4.2 10 CFR 61.41 – PROTECTION OF THE GENERAL POPULATION FROM RELEASES OF RADIOACTIVITY (UAC RULE R313-25-20)

Figure 4-5 – Mean radon flux in the embankment

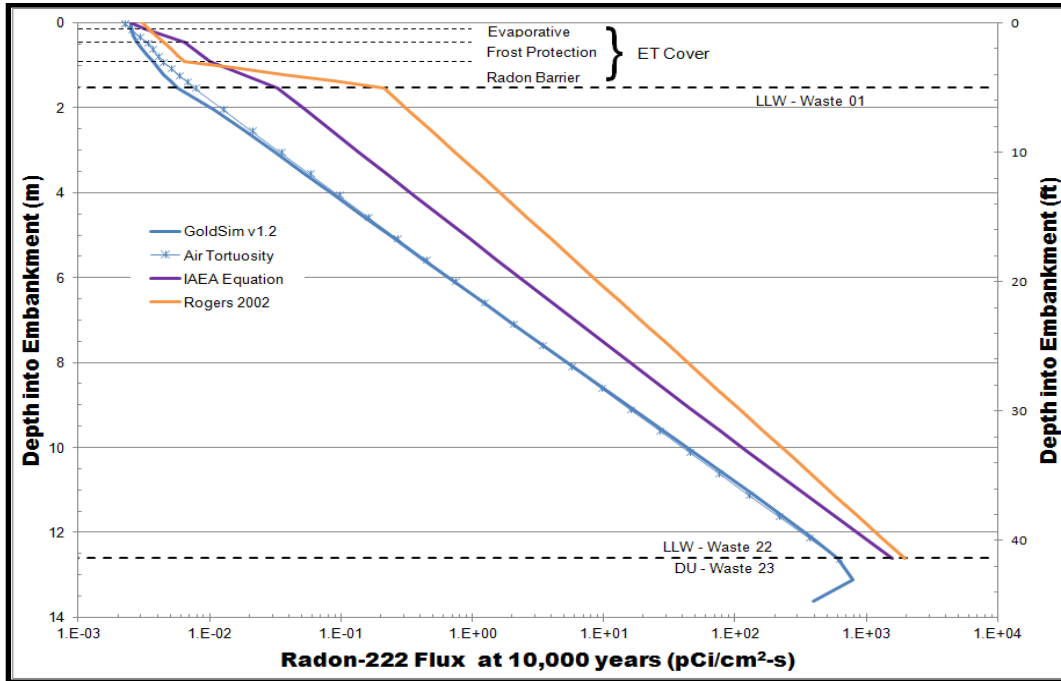
The first thing to notice about Figure 4-5 is that all of the calculated ground surface fluxes are about the same, as shown in Table 4-4 (column 2).

Second, there is a large difference between the GoldSim v1.2 radon attenuation in the ET cover and the ET cover attenuation calculated by either the IAEA Equation or Rogers 2002. For both the IAEA Equation and Rogers 2002, the attenuation provided by the radon barrier layers is clearly shown in Figure 4-5, but for the GoldSim v1.2 there is virtually no attenuation by the radon barrier layers [Table 4-4 shows only an attenuation of 2.3 (i.e., 0.0057 picocuries per

square meter per second [$\text{pCi/m}^2\text{-s}] \div 0.0025 \text{ pCi/m}^2\text{-s}$) for GoldSim v1.2]. In fact, close examination of the Figure 4-5 GoldSim v1.2 curve shows that there is less attenuation per unit thickness in the radon layers than there is in the waste layers. This is due to the different correction factors that EnergySolutions/Neptune calculated and applied (i.e., 0.394 for the waste layers and 0.894 for the radon barrier layers) and Equation (4)'s linear relationship between moisture content and diffusion coefficient. In other words, the increase in the correction factor more than compensated for the increase in the moisture content.

The Air Tortuosity curve in Figure 4-5 agrees well with the GoldSim v1.2 radon flux, indicating that GoldSim v1.2 is performing the calculations as described in the Clive DU PA Model v1.2 documentation (Neptune 2014j).

Figure 4-6 – Time-dependent lower aquifer groundwater ingestion dose

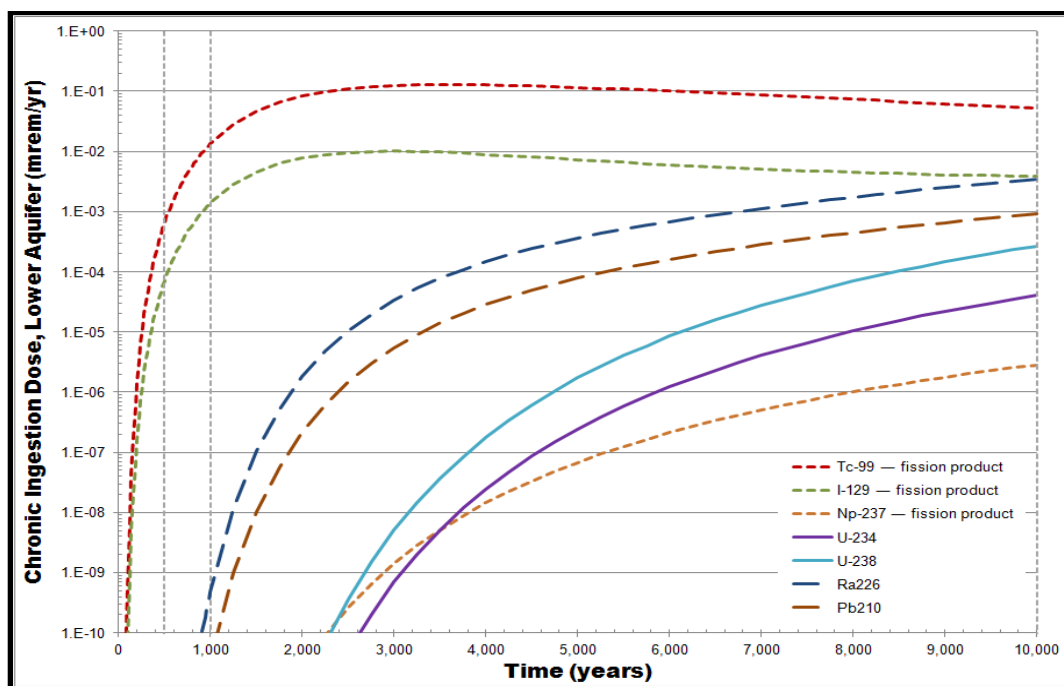
At 10,000 years, Tc-99 is still the dominant contributor to dose.

Figure 4-7 – Ingestion dose at 10,000 years versus infiltration rate

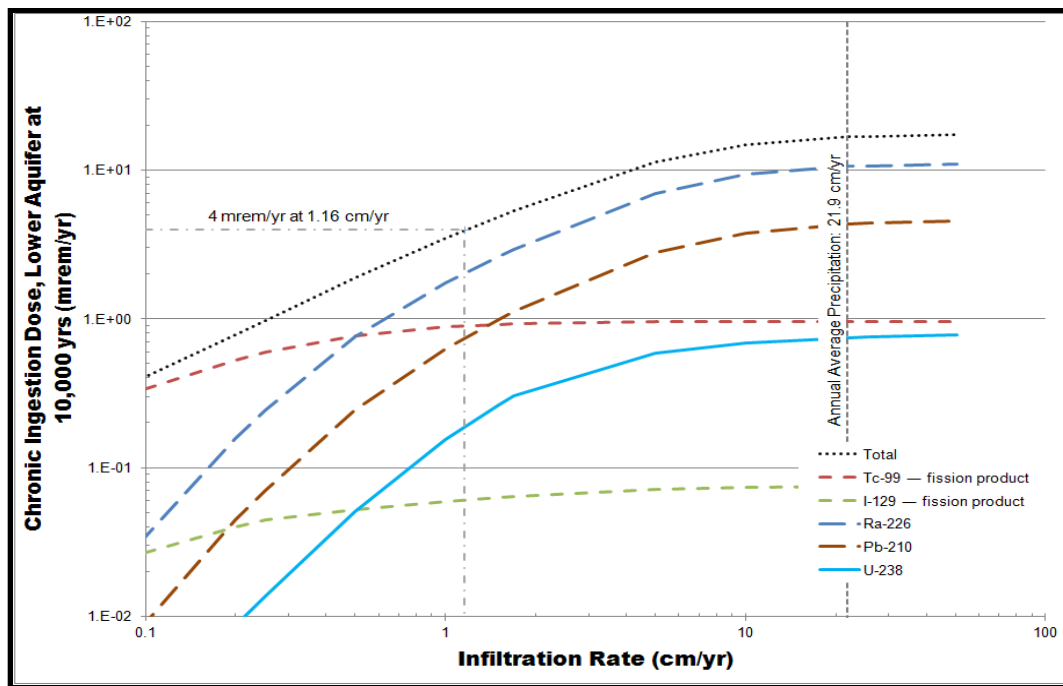
To provide additional perspective on the significance of the groundwater ingestion pathway, DEQ performed a bounding calculation in which it was assumed that the yield from the upper aquifer was sufficient to provide enough water to support a household. As discussed above, this scenario is bounding because the yield from the upper aquifer is not sufficient to support such a scenario. This calculation, which is summarized in Table 3 of Marschke (2015), shows that for time periods up to 10,000 years, a 1:11 dilution of upper to lower aquifer water is necessary to reduce the calculated dose to below the UAC R313-25-19 dose-from-groundwater limit of 4 mrem/yr. However, if disposal of DU-containing recycled uranium is not permitted as proposed in this SER, then the bounding undiluted upper aquifer groundwater ingestion dose is 1.4 mrem/yr, which is below the UAC limit.

As discussed below in Section 4.4.1, there is much uncertainty regarding the infiltration rate that was utilized in DU PA v1.2. Figure 4-7 shows how the calculated chronic groundwater ingestion dose would vary as a function of the infiltration rate, with all other parameters remaining the same as for the Table 4-5 and Figure 4-6 doses. When viewing Figure 4-7, keep in mind that the mean infiltration rate used in DU PA v1.2 was 0.0344 cm/yr (see Section B.7, page B-11). Figure 4-7 shows that, if the infiltration rate exceeds 1.16 cm/yr, the chronic groundwater ingestion dose from this exposure pathway would exceed the UAC R313-25-19 groundwater exposure dose limit of 4 mrem/yr.

Figure 4-9 – Correlation of saturated hydraulic conductivity and van Genuchten alpha

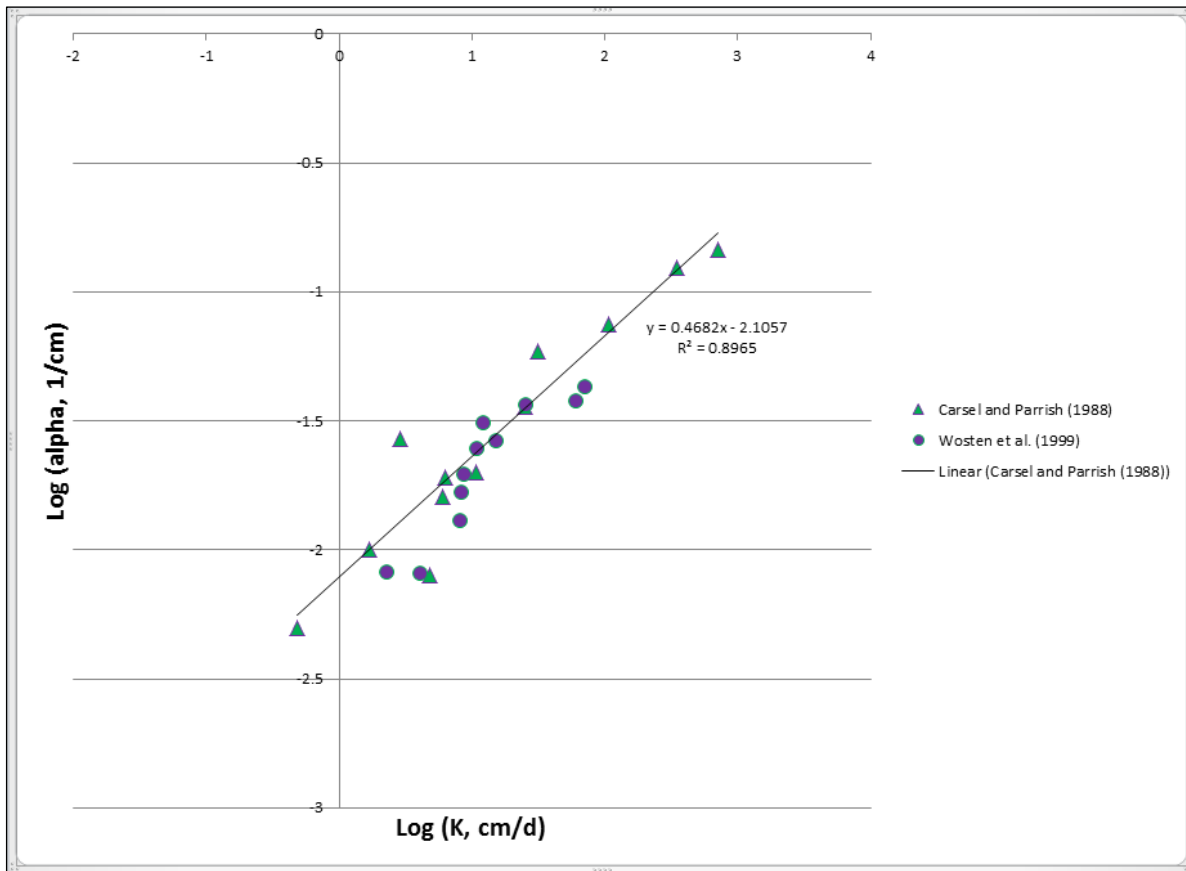
Carsel and Parrish (1988) grouped a soil data set of 5,093 samples with reported K_{sat} (shown as “ K_s ” in Figure 4-9) and α values into 12 U.S. Department of Agriculture soil textural classifications (e.g., sandy loam). This is the largest North American database dedicated to hydraulic properties of soils. In Figure 4-9, DEQ has plotted K_{sat} versus α for each of the 12 soil textural classifications. A regression of the data indicates a very strong correlation ($R^2 = 0.8965$) between $\log(\alpha)$ versus $\log(K_{sat})$. Wösten et al. (1999) collected data from 20 institutions of higher learning in 12 European countries to develop the database HYPRES (Hydraulic Properties of European Soils). This is the largest European database dealing with hydraulic properties of soils. Wösten et al. (1999) grouped their data into 11 soil textural classifications, each with reported K_{sat} and α values. As shown in Figure 4-9, these data exhibit some variability but generally fall in a similar range to the Carsel and Parrish (1988) data.

Given these data sets in the professional literature, it is not clear that *EnergySolutions* has used appropriate data for the saturated hydraulic conductivity or reflected the correlation between $\log(\alpha)$ and $\log(K_{\text{sat}})$ or between α and K_{sat} . In its response to Round 3 Interrogatory CR R313-25-7(2)-189/3: Modeling Impacts of Changes in Federal Cell Cover-System Soil Hydraulic Conductivity and Alpha Values (ES 2014b), *EnergySolutions* stated that there was no correlation found between K_{sat} and α . It plotted the Rosetta database (Schaap 2002) values on a plot similar to Figure 4-9 and stated that there was no correlation. The Carsel and Parrish (1988) database is a much larger database (about an order of magnitude larger than the Rosetta database). The Wösten et al. (1999) database is also quite large. Furthermore, an equation exists for the relationship between α and K_{sat} based on soil physics that can be readily shown to be transformable to $\log(\alpha) = 0.5 \times \log(K_{\text{sat}}) - 2.14$, which is nearly identical to the correlation equation for the Carsel and Parrish (1988) data (Guarracino 2007). Meyer et al. (1997) and Zhu et al. (2007) have also described correlation between $\log(\alpha)$ and $\log(K_{\text{sat}})$ or between α and K_{sat} . Given the apparent differences in the Rosetta database and that of Carsel and Parrish (1988) and others regarding whether or not correlation exists between α and K_{sat} , it would seem that a comparative analysis should be undertaken.

Figure 5-1 – Mean radon flux above depleted uranium

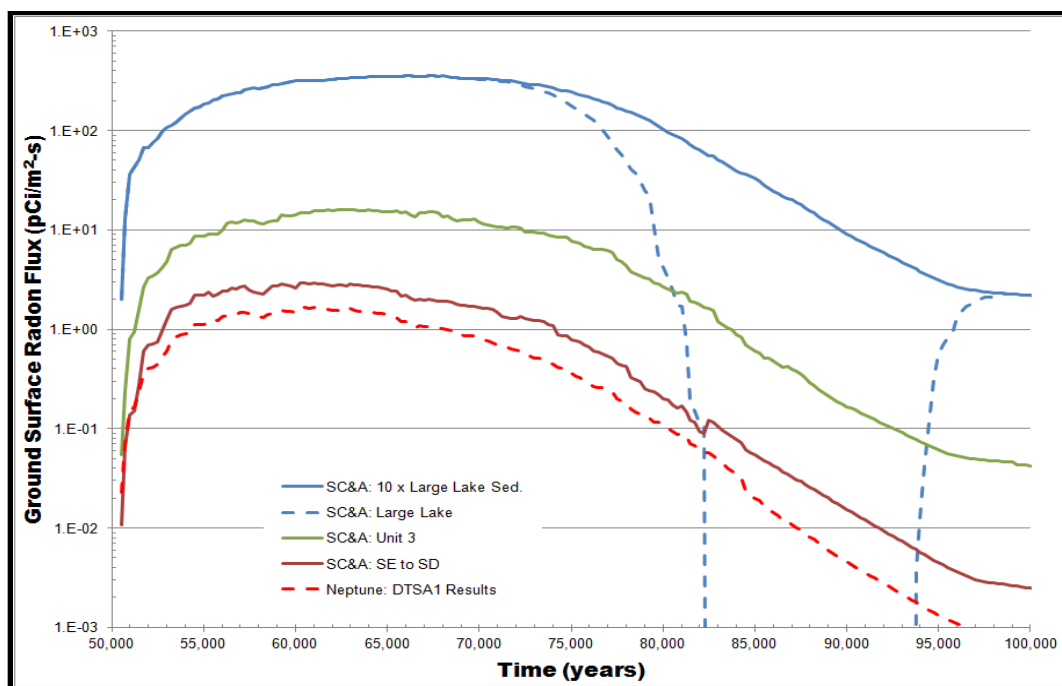
DTSA1 results. From these ratios, it can be seen that reducing the Intermediate Lake's sedimentation rate to 10 times the Large Lake's sedimentation rate results in the largest increase in the peak mean radon flux. Also, when all four of the SC&A assumption modifications are taken into account, the peak mean radon flux is about 350 times larger than the flux reported in the *EnergySolutions/Neptune* revised DTSA (Neptune 2015a).

The Figure 5-1 dashed blue curve (SC&A: Large Lake) is the same as the SC&A: 10x Large Lake case (the solid blue curve) except that ground surface radon flux has been set to zero whenever a Large Lake is present. Because their durations are about the same length as the time-step used in the GoldSim model, it was not feasible to set the radon flux to zero during the presence of an Intermediate Lake. Since the peak mean radon flux occurs following the first Intermediate Lake, setting the flux to zero during the presence of a Large Lake has no impact on the peak mean radon flux, as shown by Figure 5-1.

Figure 5-3 – Comparison of standard error to standard deviation

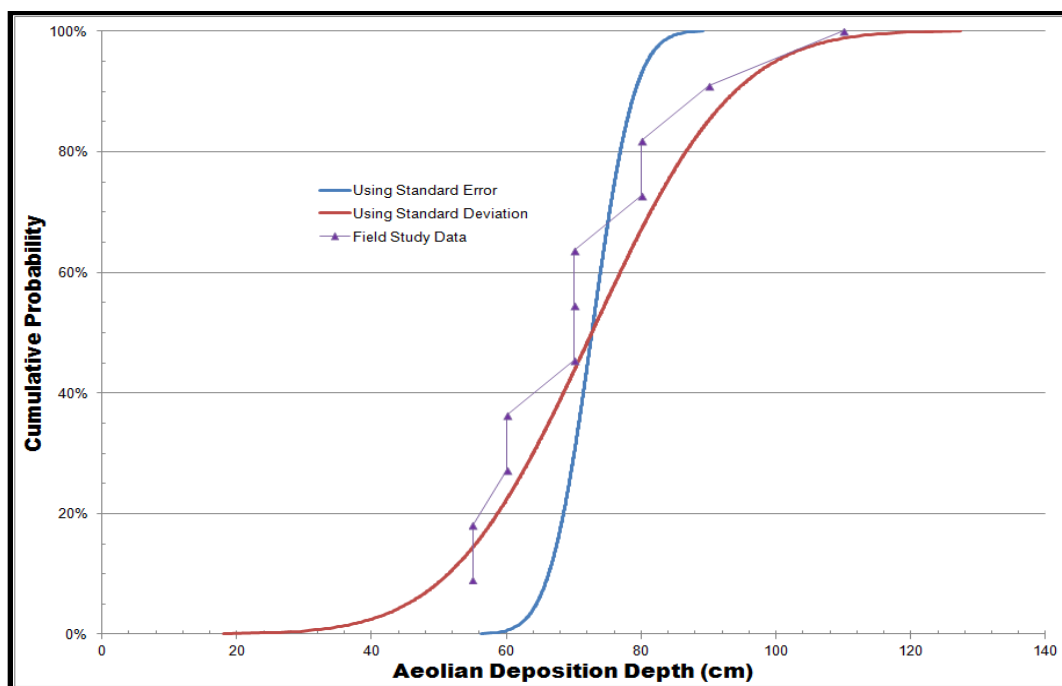
Figure 5-3 shows that the “tails” of the standard error distribution are much shorter than the “tails” of the standard distribution. In fact, the aeolian deposition depth calculated from the standard error distribution never reaches the maximum depth of 110 cm that was measured in the field studies. It is believed that the Figure 5-3 standard deviation curve is a much better match to the field study data than the Figure 5-3 standard error curve.

For all subsequent GoldSim analyses, SC&A used an aeolian deposition distribution as described by Neptune (2015a), except that the aeolian deposition depth distribution was described using the standard deviation of 16.6 cm, rather than by the standard error of 5.0 cm. As shown in Table 5-1, this change results in an increase in the GoldSim-calculated ground surface radon flux by about a factor of 1.7 over what was reported by EnergySolutions/Neptune (Neptune 2015a).

Figure 5-5 – Comparison of Intermediate Lake sedimentation rates

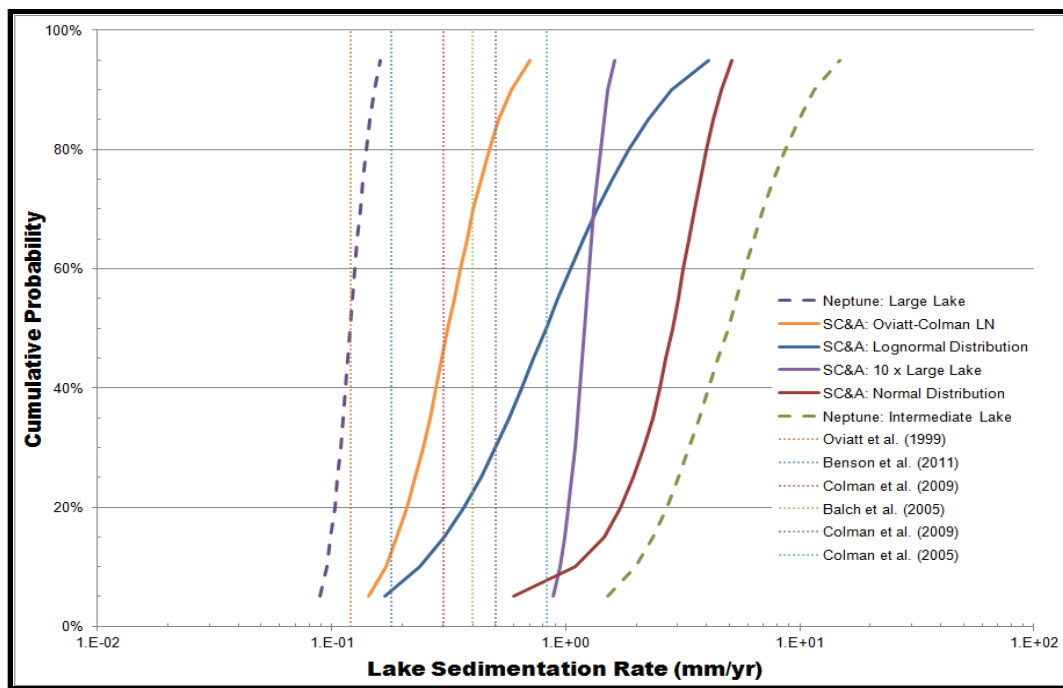
From Dr. Jewell’s information, it can be concluded that a sedimentation rate of 1.2 mm/yr for intermediate lakes is likely too large, thereby understating the radon flux. Thus, in order to provide additional perspective, SC&A investigated three other hypothetical sedimentation rates for the Intermediate Lake based on the available data: (1) a normal distribution based on the Large and Intermediate Lake means (0.12 and 5.64 mm/yr, respectively), (2) a lognormal distribution based on the Large and Intermediate Lake means, and (3) a lognormal distribution based on the smallest [0.12 mm/yr from Oviatt et al. (1999)] and largest [0.83 mm/yr from Colman et al. (2009)] Table 5-2 sedimentation rates. Figure 5-5 shows each of these lake sedimentation rate distributions, while Table 5-3 presents the characteristics of the analyzed Intermediate Lake Sedimentation rate distributions. Also shown in Figure 5-5 are the

Figure 5-6 – Mean radon flux with different sedimentation rates

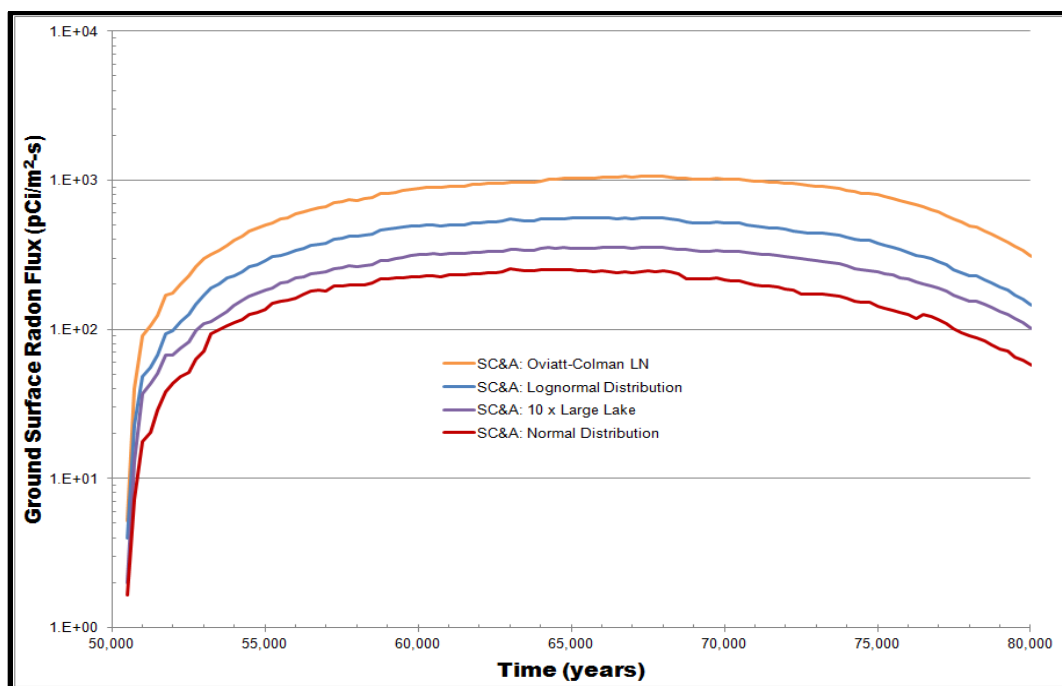
SC&A re-ran the DTSA GoldSim model with each of the Figure 5-5 sedimentation rates, with the resulting ground surface radon fluxes shown in Figure 5-6 and the peak mean flux given in Table 5-4.

Figure 5-7 – Dose rate above covered depleted uranium

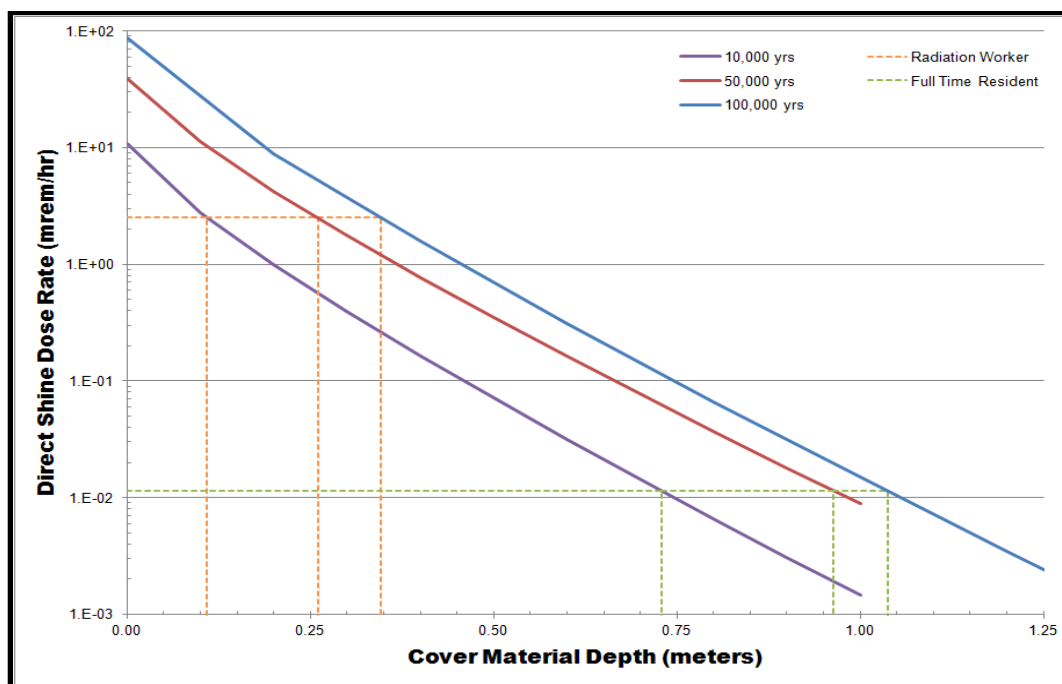
The dashed lines in Figure 5-7 show the amount of cover material needed to reduce the direct shine dose to below the UAC R313-15-201(1)(a)(i) occupational limit of 5 rem/yr (the orange line), assuming 2,000 work-hours/year and below the UAC R313-15-301(1)(a) dose limit for individual members of the public of 100 mrem/yr (the green line), assuming full-time (i.e., 8,766 hr/yr) occupancy. Table 5-7 shows the various amounts of cover material necessary to reduce the direct shine dose to each of the two limits.

Figure 5-9 – DEQ-calculated fraction of GWPL for various radionuclides as a function of time based on all DU PA inventory at the 90-foot well (unconfined aquifer)

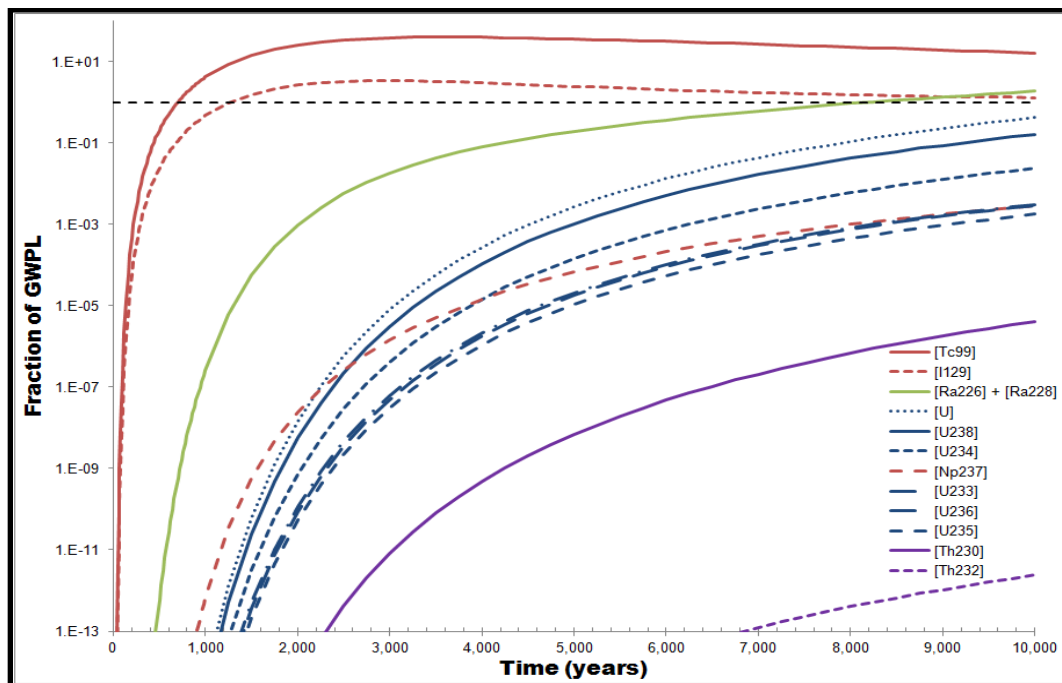
Even though Figure 5-9 shows that after the 500-year GWQ Permit evaluation period some of the GWPLs are exceeded, the groundwater ingestion analysis discussed in Section 4.2.2 indicated that the UAC Rule R313-25-20 groundwater pathway dose limit of 4 mrem/yr is not exceeded.
